RESOLUTION MSC.226(82)  
(adopted on 8 December 2006)  
ADOPTION OF AMENDMENTS TO THE REVISED  
RECOMMENDATION ON TESTING OF LIFE-SAVING  
APPLIANCES, AS AMENDED

**RESOLUTION MSC.226(82)**

**ADOPTION OF AMENDMENTS TO THE REVISED RECOMMENDATION  
ON TESTING OF LIFE-SAVING APPLIANCES, AS AMENDED**

### AMENDMENTS TO THE REVISED RECOMMENDATION ON TESTING OF LIFE-SAVING APPLIANCES, AS AMENDED

**Figure 4 – Stretcher dimensions (mm)**

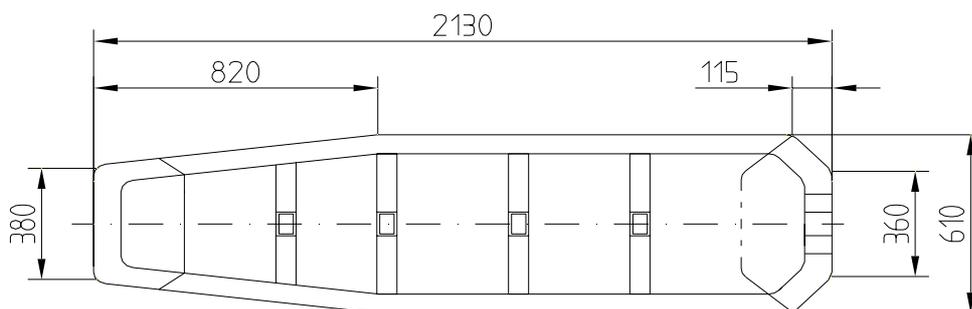
25 In paragraph 7.1.3, in the second sentence, the words “on a stretcher of similar dimensions to those shown in figure 4” are inserted between the words “lie down” and “and the others” and the following figure is inserted after the paragraph:
